**AREA 3 FIELD SAMPLING PLAN**  
**ADDENDUM TO REMEDIAL INVESTIGATION**  
**WORK PLAN**  
**FOR PER- AND POLYFLUOROALKYL SUBSTANCES**  
**(PFAS)**

**FORMER FORT DEVENS ARMY INSTALLATION, DEVENS, MA**

**JULY 2020**

Date: 01/02/2020	Figure 4	
--	---------------------	-------------	--

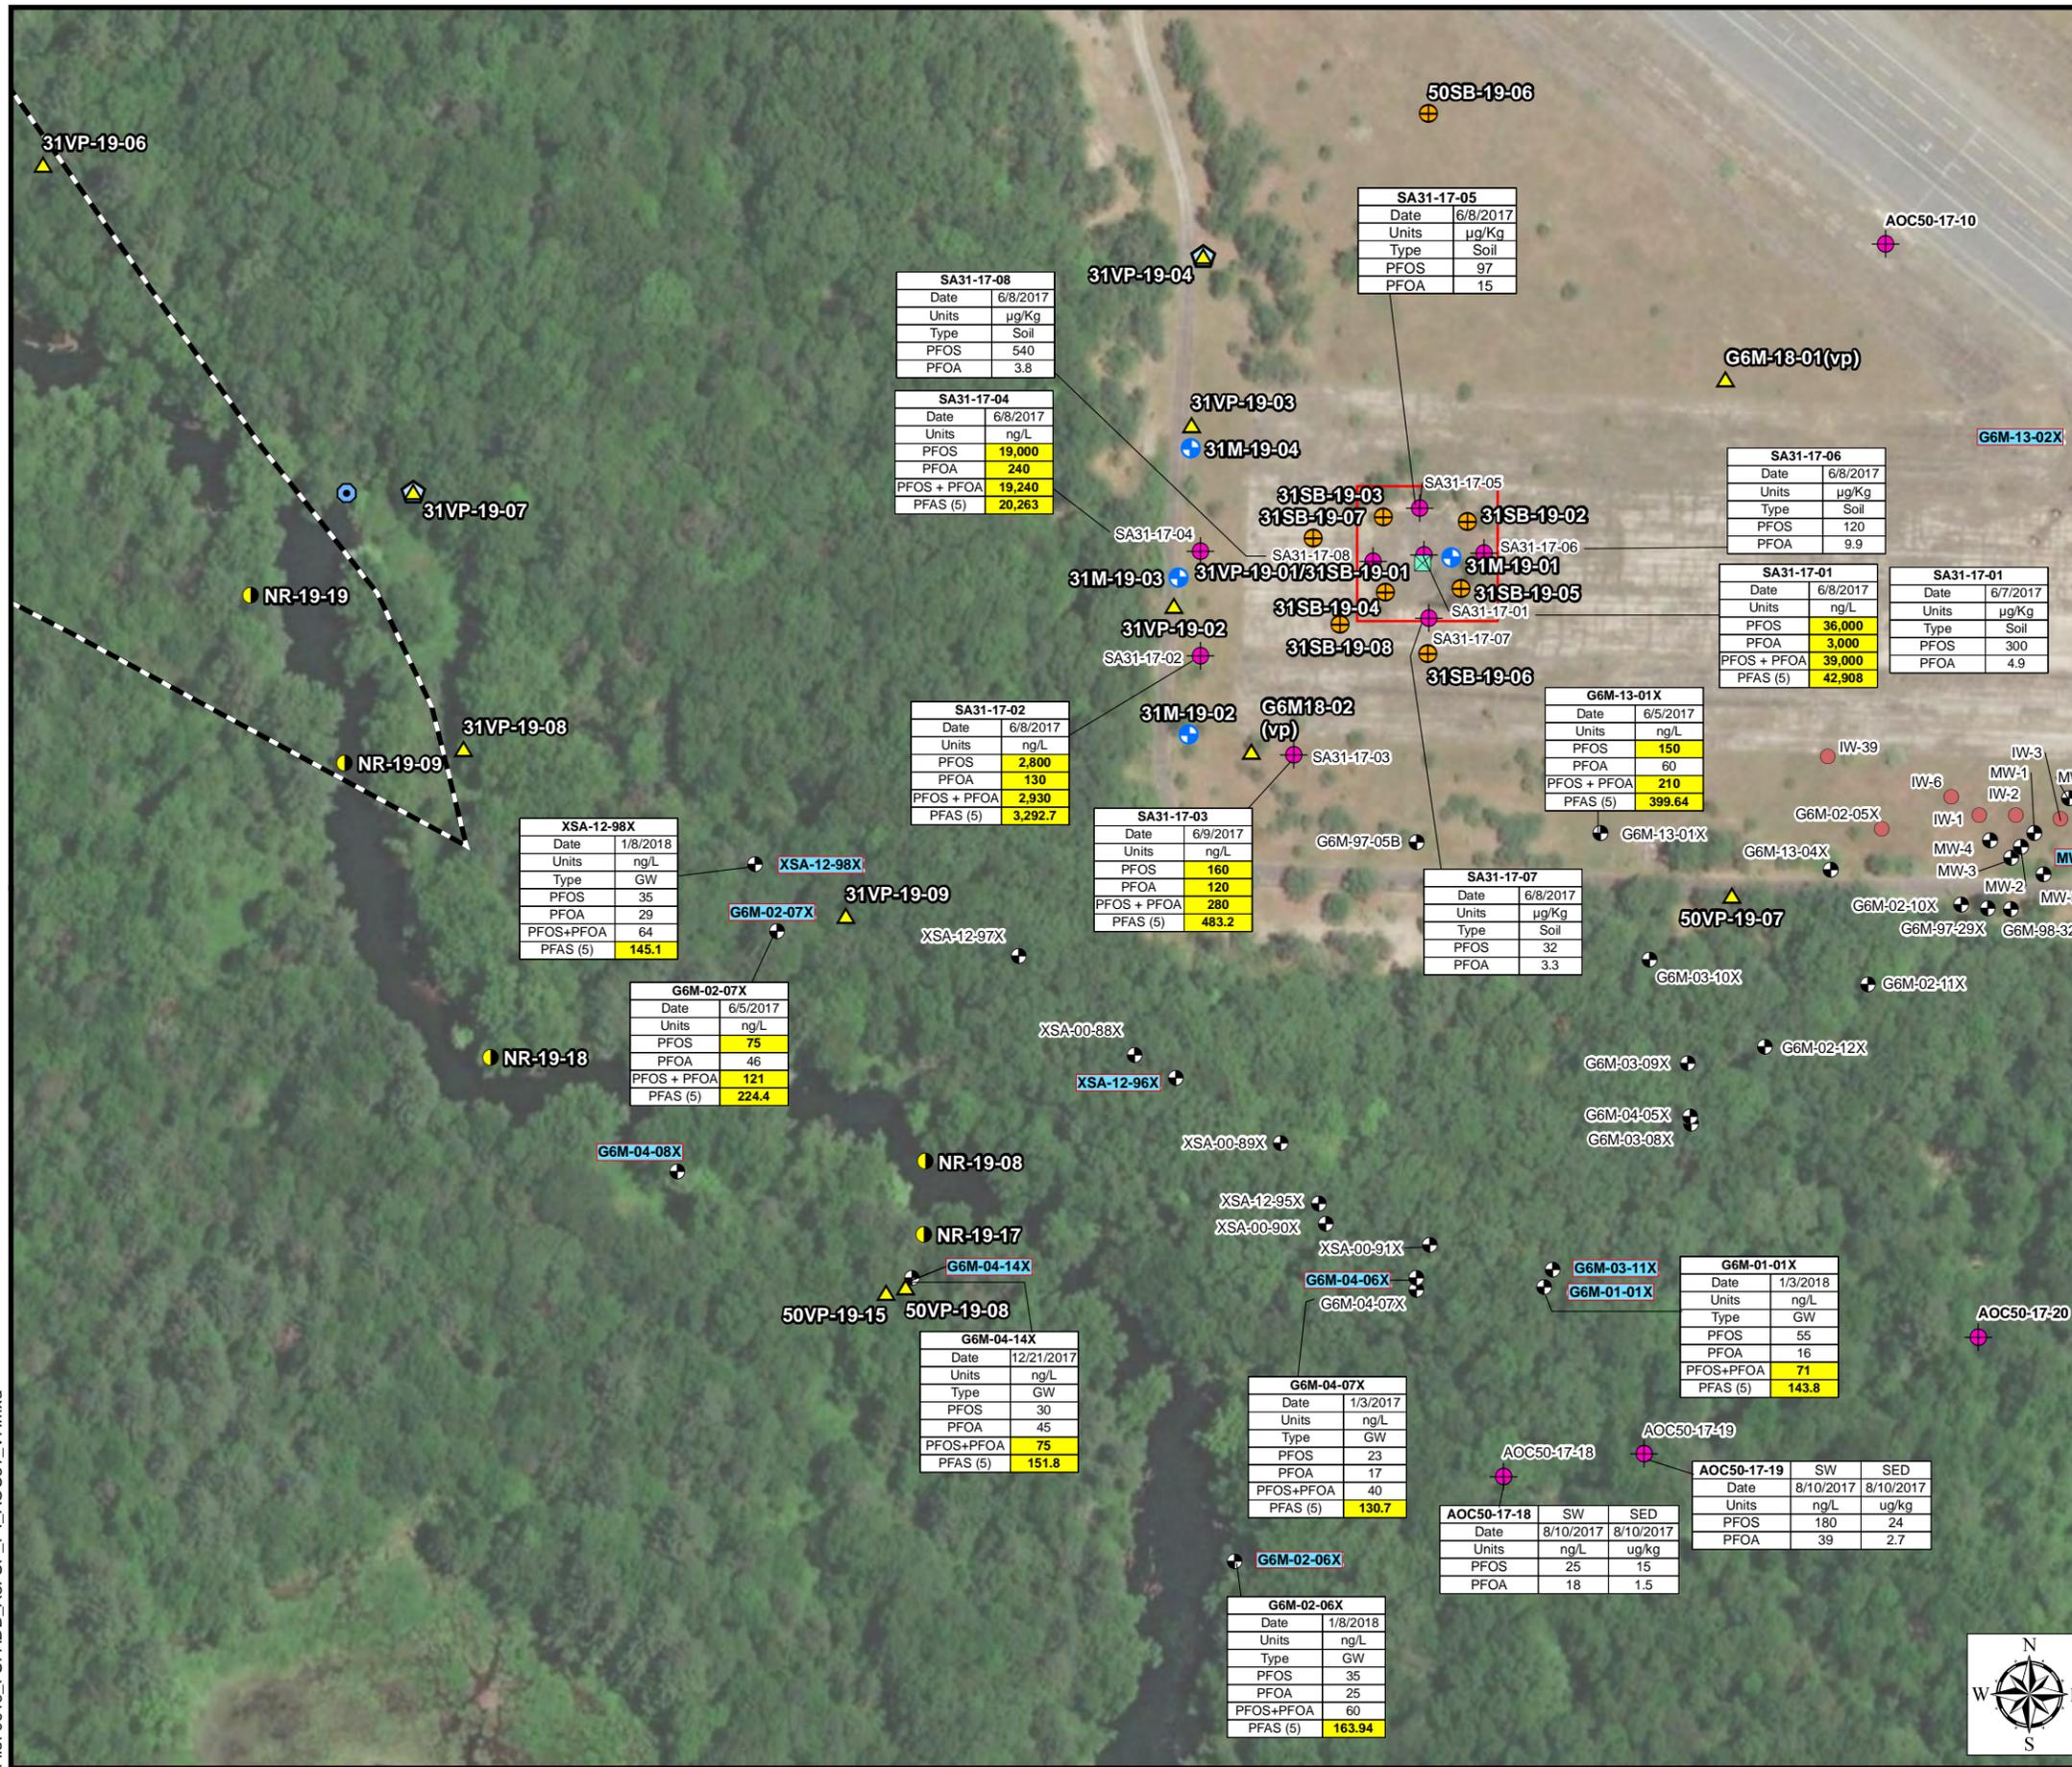
22. Figure 4 – Please confirm that the existing wells to be sampled are screened at elevations consistent with the depth of detections at G6M-18-01VP and G6M-18-02VP. If not, additional vertical profiles should be installed downgradient of G6M-18-02VP.

**SC Comment #7:** Figure 4 – It is reported that G6M-18-01VP contained “high detections of PFAS.” The aerial photographic base shows evidence of a rectangular area of disturbed ground that abuts G6M-18-01VP to the south and includes the delineated Area of Contamination (AOC). Is there evidence that fire training occurred within this disturbed area, such that the elevated detections in G6M-18-01VP indicate a localized source rather than eastward groundwater

migration from the AOC as it is delineated on Figure 4? Vertical profiling points near G6M-18-01VP may help distinguish a localized source from a contaminant migration pathway toward this profiling point.

**Comment 19. Figure 4** - There is insufficient profiling planned downgradient of the fire training area, particularly to the southwest and south. The existing wells to the southwest do not provide adequate depth differentiation to characterize the depth of contamination (three wells are screened at the same elevation). The wells to the south do cover a range of depths; however, the deepest well, XSA-00-90X, was not sampled; neither was XSA-00-91X. The next deepest well, XSA-00-88, to the southwest, was also not sampled based on the data provided by Army. All three of these wells are highlighted in blue indicating that that were to be sampled. EPA recommends soil sampling at the water table for one of the two borings outside the fire training limits.

**Comment 7.** Figure 4 – XSA-00-88X and XSA-00-90X are reportedly not usable per Army RTCs; however, these wells were needed to provide data for deeper groundwater downgradient of AOC 31 (PFAS was detected in excess of the LHA at G6M-01-01X which is screened at 134-114 NGVD29; none of the other wells proposed for sampling are that deep.). If these wells cannot be made usable then it will be necessary to install vertical profiles at XSA-00-88X and XSA-00-90X to refusal to determine the depth of PFAS contamination in these locations.

**Comment 8.** Figure 4 – The extent of PFAS contamination at the southern end of AOC 31 has not been defined as indicated by LHA exceedances in downgradient wells.

**Response:** As identified on Figure 4 and 5, the area of disturbed ground that abuts G6M-18-01VP to the south is AOC 31, a former Fire Training Area (FTA). AOC 31 is addressed in the *Final Base-wide Preliminary Assessment for Evaluation of Perfluoroalkyl Substances, Former Fort Devens Army Installation* (KGS, 2017), the *Draft Remedial Investigation Work Plan for Per- and Polyfluoroalkyl Substances (PFAS)* (KGS, 2018), and in the Area 3 FSP.

Figure  
5

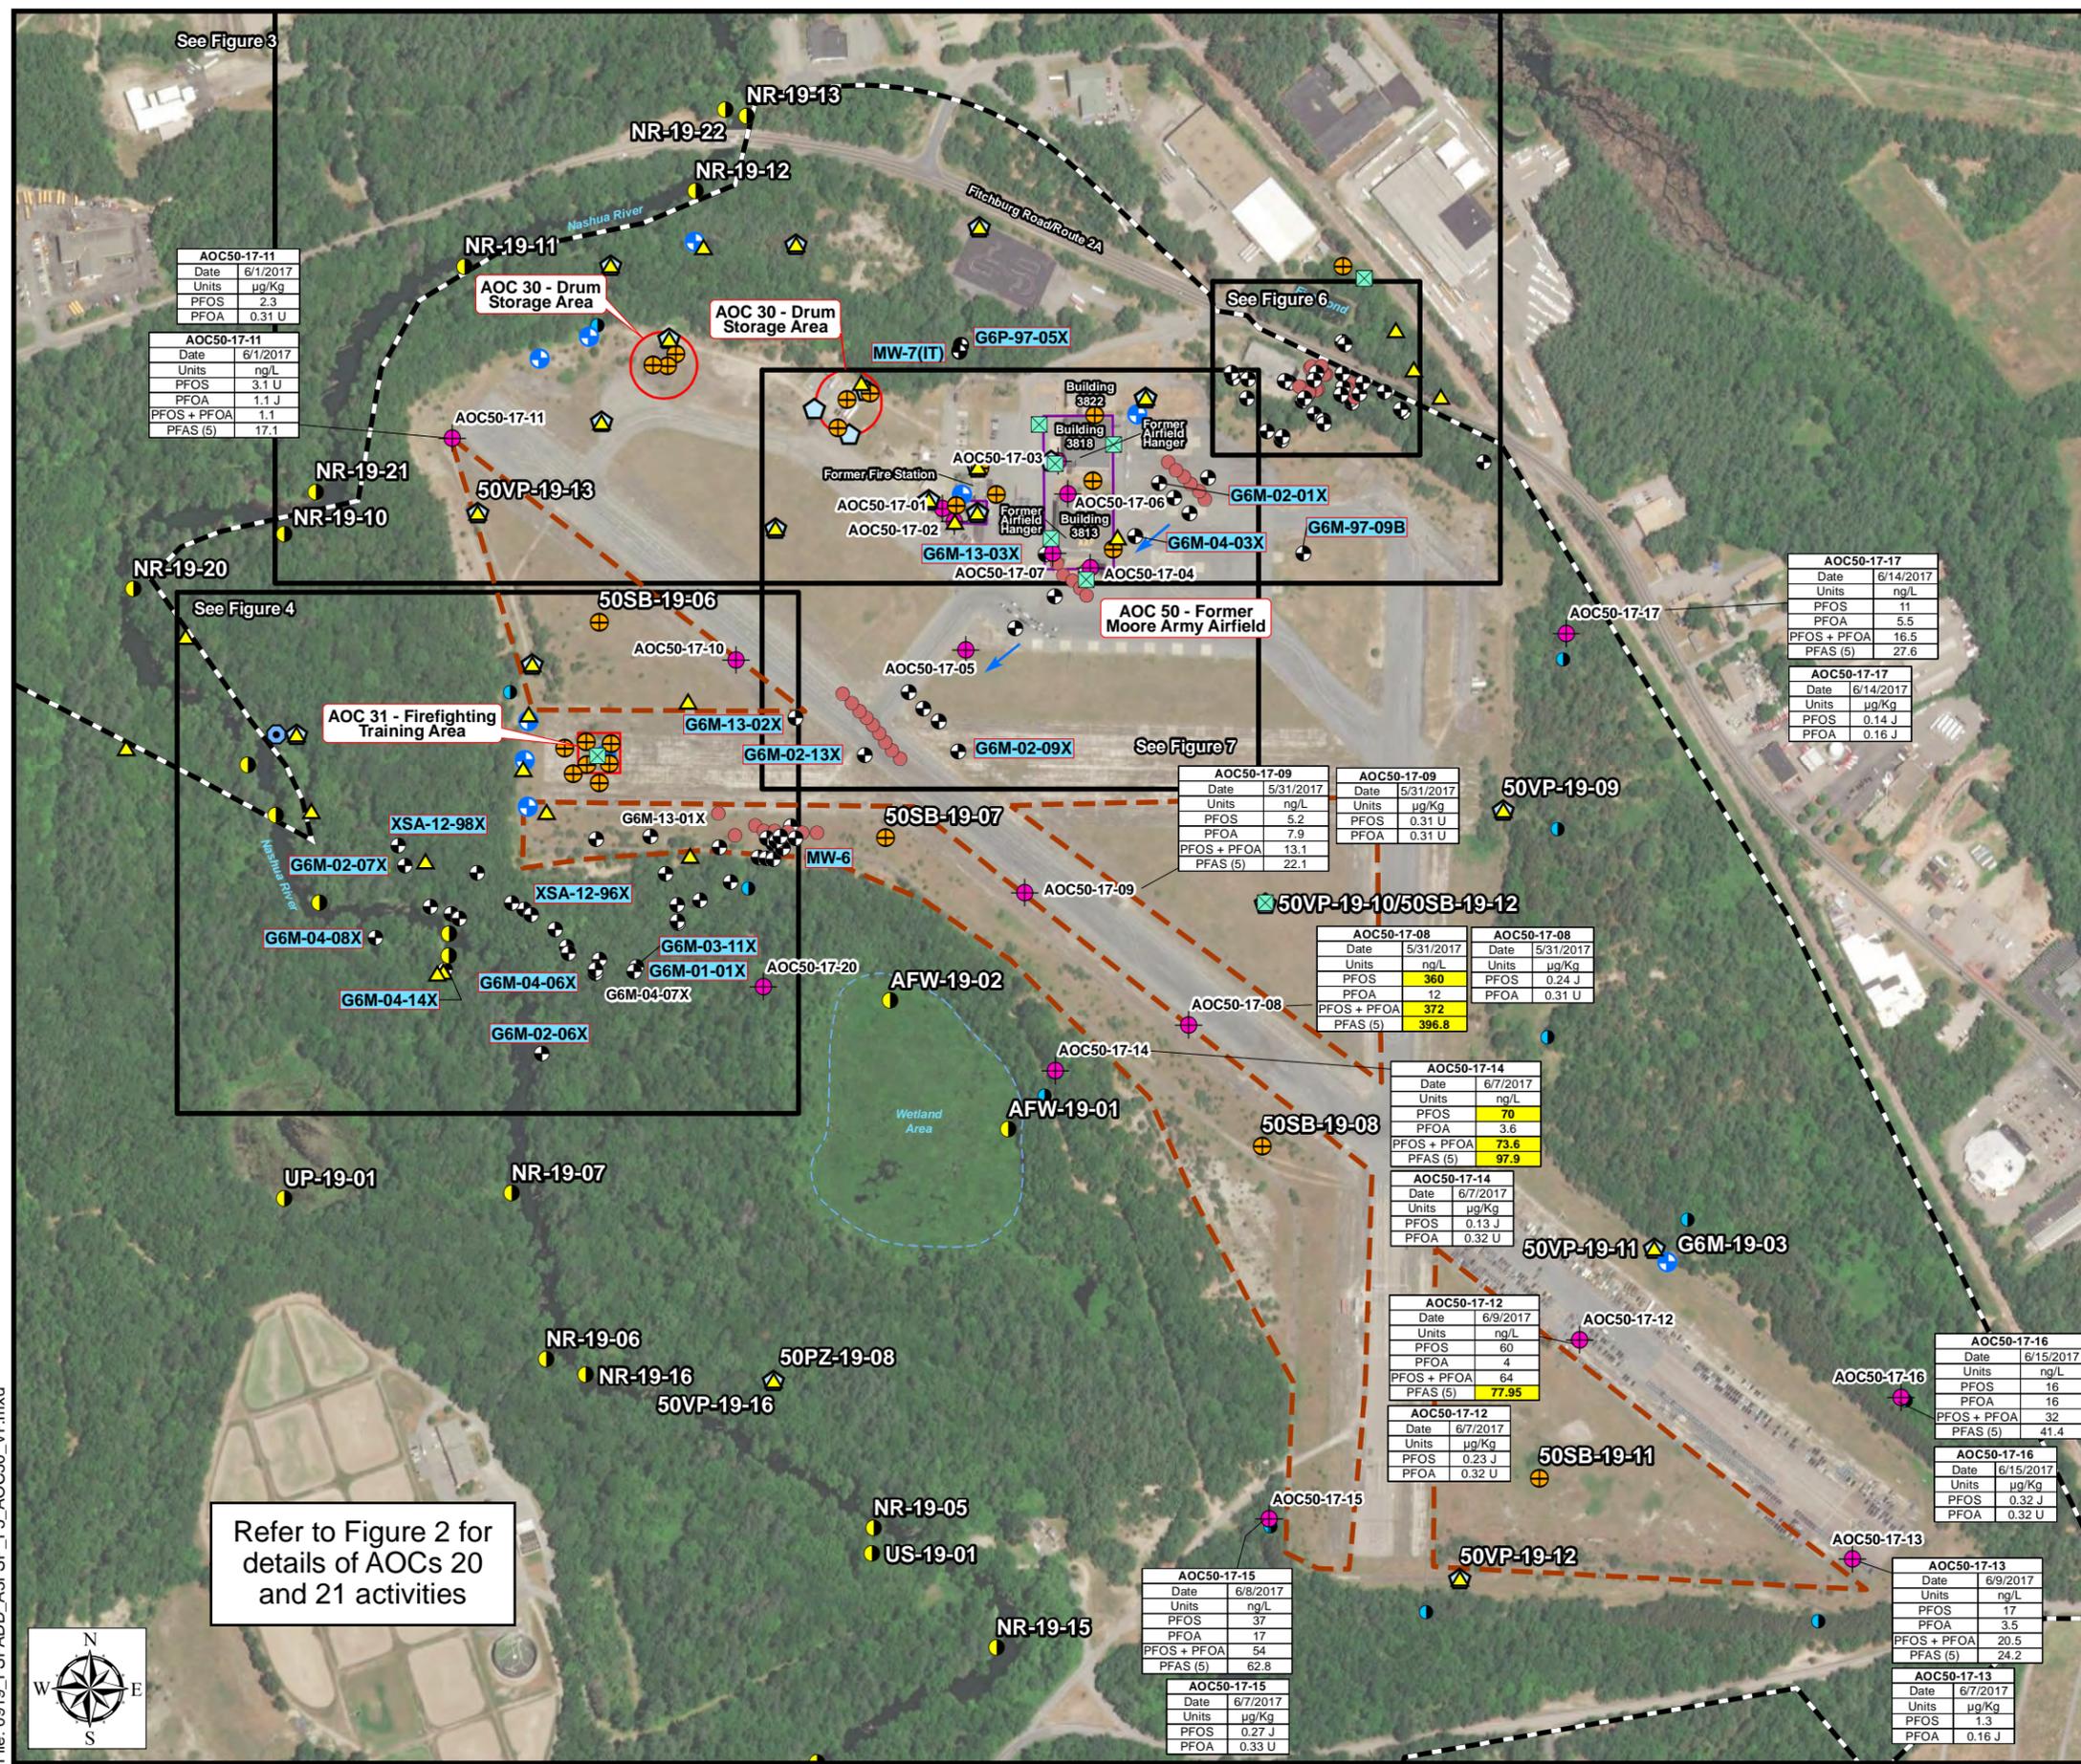
23. Figure 5 – Please add missing location G6M-18-01VP to the figure.

24. Figure 5 - Additional new wells are needed between boring 50SB-19-06 and former well AOC50-17-11 to fill a spatial data gap between the source areas and the river.

**Comment 20. Figure 5** - The only investigations currently proposed downgradient (southwest) of AOC50-17-08 are SW/SED samples. That alone will not be sufficient to characterize contamination and evaluate impacts in that portion of the site.

**Comment 9.** Figure 5 – Add another vertical profile and piezometer at AOC50-17-14 and at or north of AOC50-17-15, add a vertical profile at 50SB-19-07, and add a piezometer in the vicinity of AOC50-17-

**Comment 10. Figure 5** – Add another vertical profile and piezometer halfway between G6M-01-01X and 50VP-19-16 to define the extent of PFAS south of G6M-01-01X and to provide better groundwater flow characterization.

**Comment 11. Figure 5** – Considering the known PFAS concentrations at the south end of the flight line it will be necessary to install permanent monitoring wells along the property boundary in that area.

**Response:** This location will be added to Figure 5.
